SUBJECT: Triangle Expressway Southeast Extension (Complete 540) from NC 55 Bypass in Apex to US 64/264 (I-87) in Knightdale, Wake and Johnston Counties; Federal Aid No. STP-0540(19), STP-0540(20), and STP-0540(21); WBS Nos. 37673.1.TA1, 35516.1.TA1, and 35517.1.TA1; STIP Project Nos. R-2721, R-2828, and R-2829

Action ID No. SAW-2009-02240; Complete 540; TIP R-2828

Also, please reference your February 26, 2021 letter, requesting modification of the permit to authorize impact changes due to an erosion issue, construction method design revisions, and construction access, for Permit Sites 32, 48, 49, and 91, within Section R-2828, as indicated in Revised Table 4, below (Temp. Wetlands impacts include non-404 hand clearing).

Subject: MODIFICATION of 401 Water Quality Certification Pursuant to Section 401 of the Federal Clean Water Act, NEUSE BUFFER RULES, and ISOLATED WETLANDS PERMIT Pursuant to IWGP100000 with ADDITIONAL CONDITIONS for Proposed construction of the Triangle Expressway Southeast Extension (NC 540) in Wake & Johnston Counties, Federal Aid Project No. STP-0540(19-21), State Project No. 37673.1.TA2, TIP Nos, R-2721, R-2828, & R-2829.  
NCDWR Project No. 20181249 version

PERMIT DRAWING  
SHEET 75 OF 171

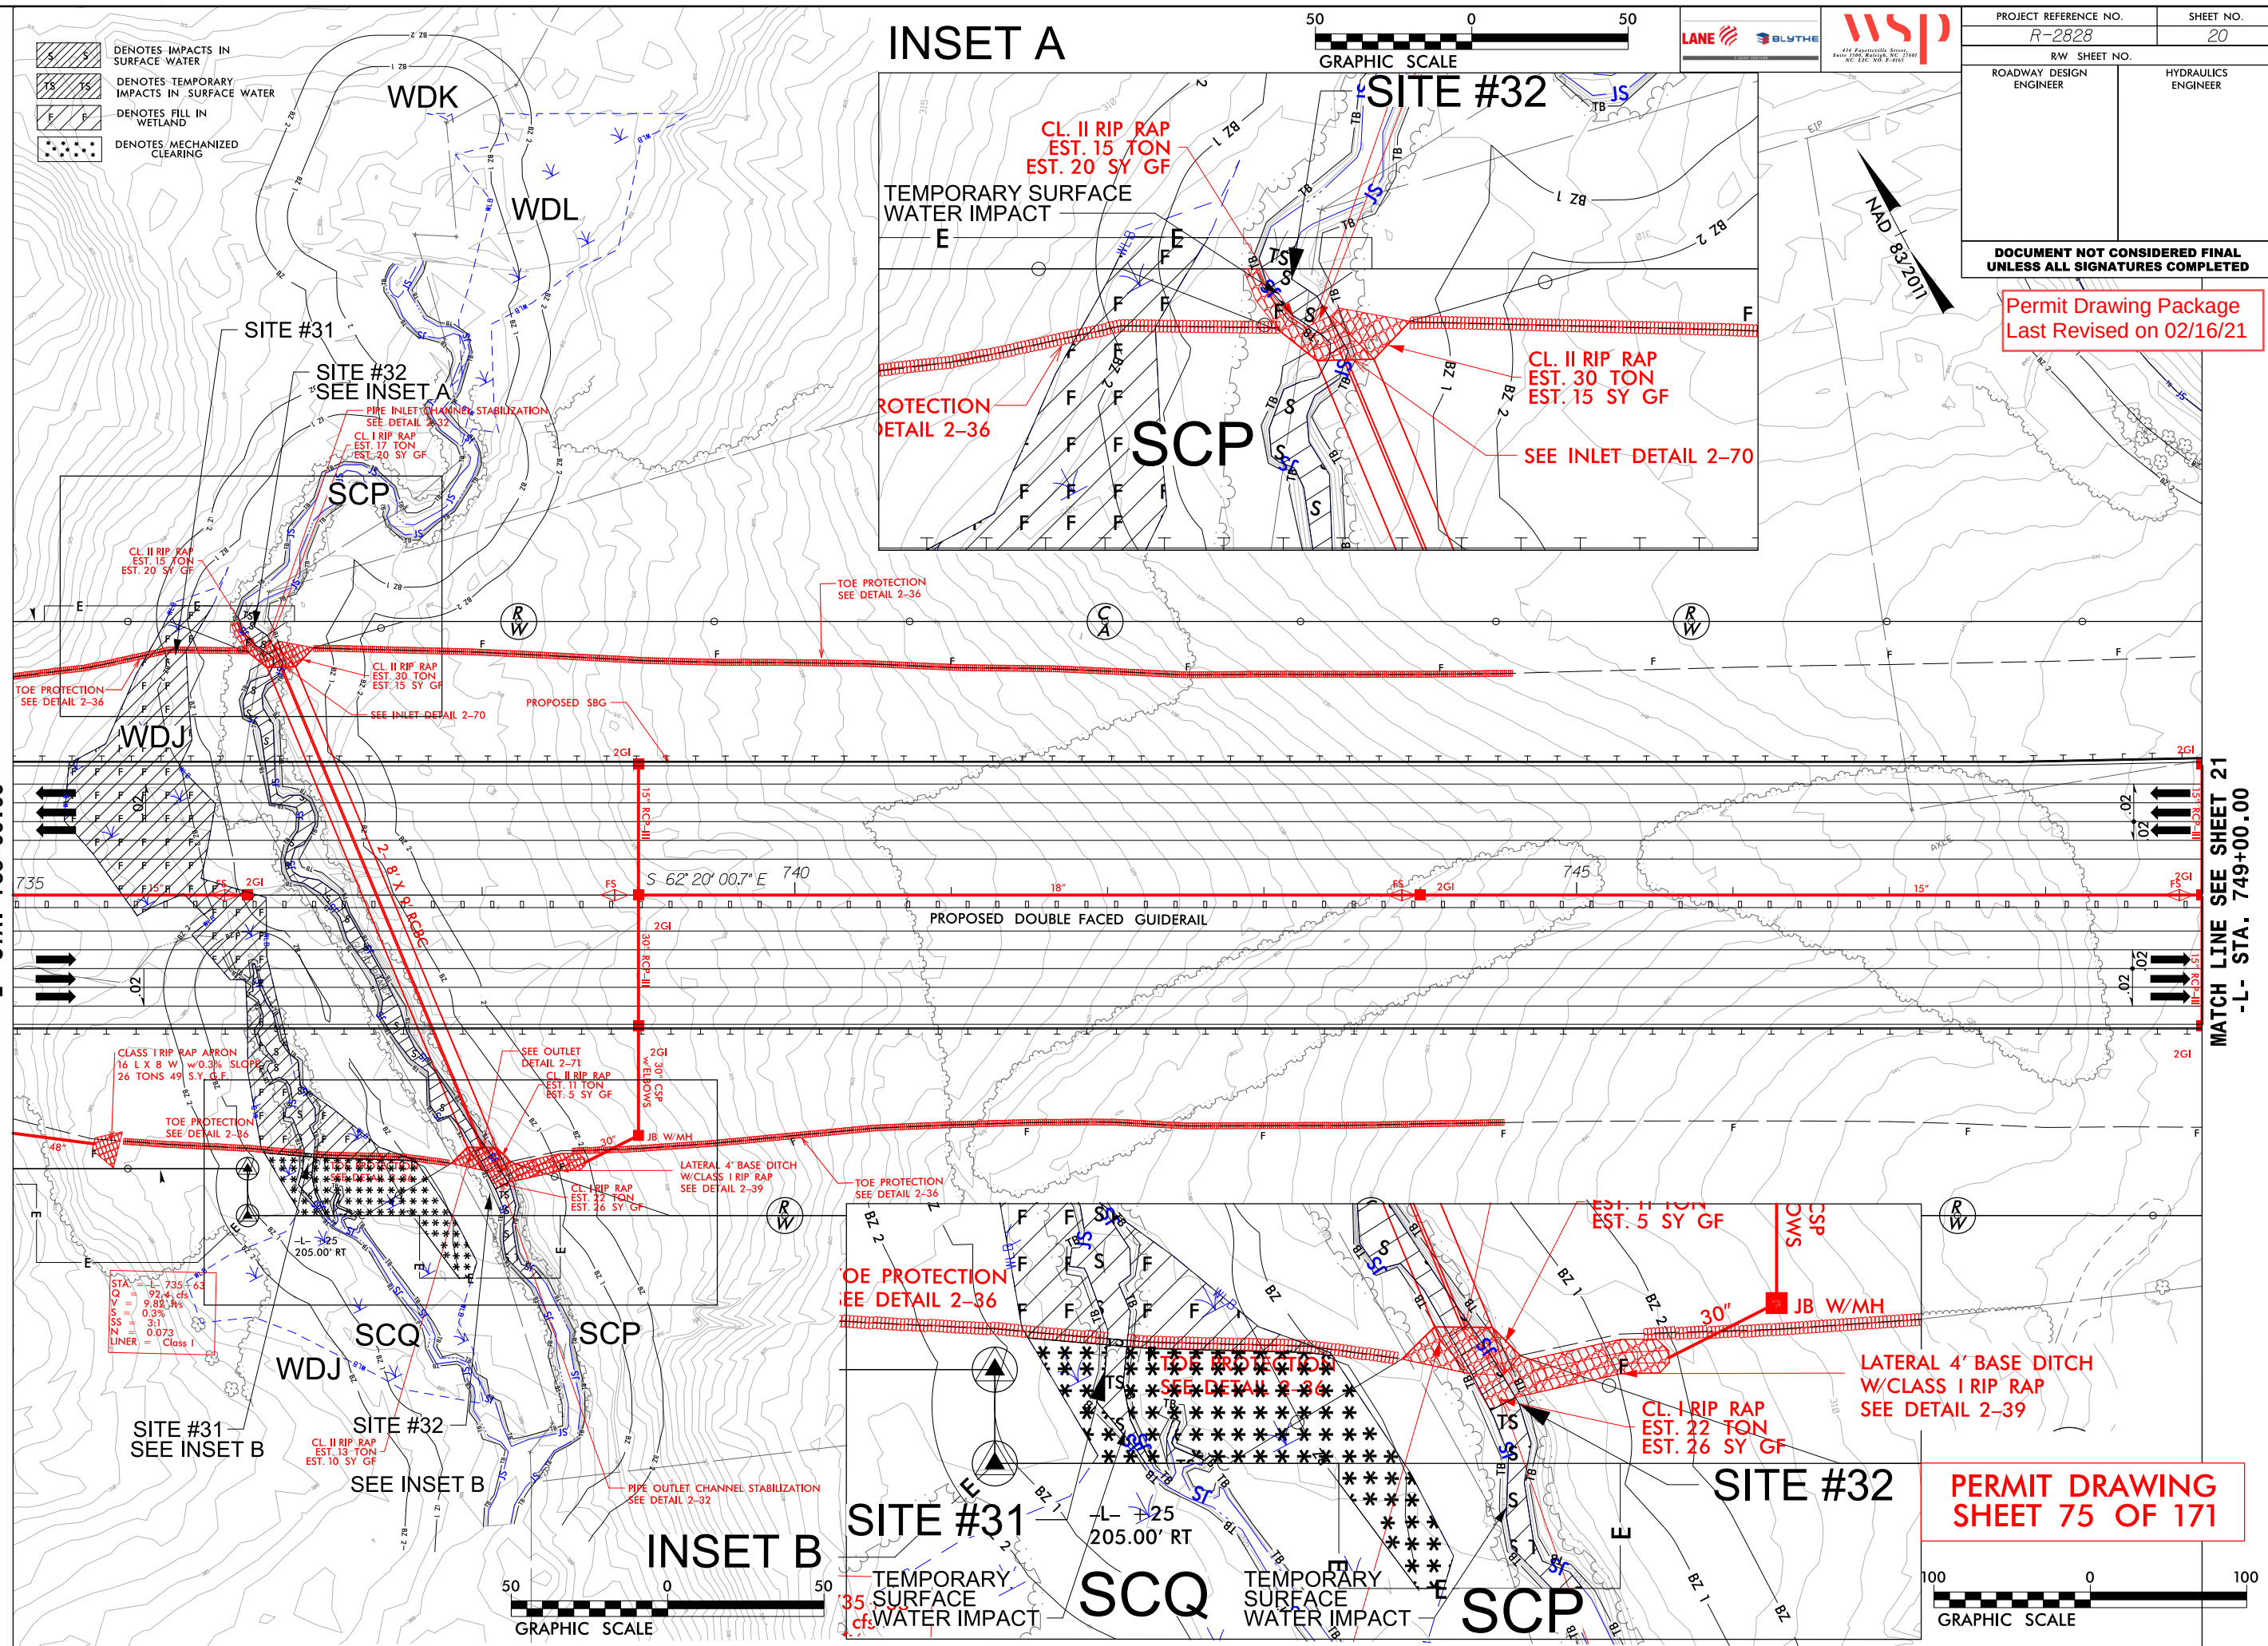
The Corps has completed the evaluation of your request and has determined that it is appropriate and reasonable, and no public notice is required for this modification. Therefore, the permit is modified as requested and as shown on the enclosed revised Permit Drawings, Sheets 1, 74, 75, 105, 106, 107, 111, 112, 132, 133, 168, 169, and 171 of 171, labeled "Permit Drawing Package Last Revised on 02/16/21."
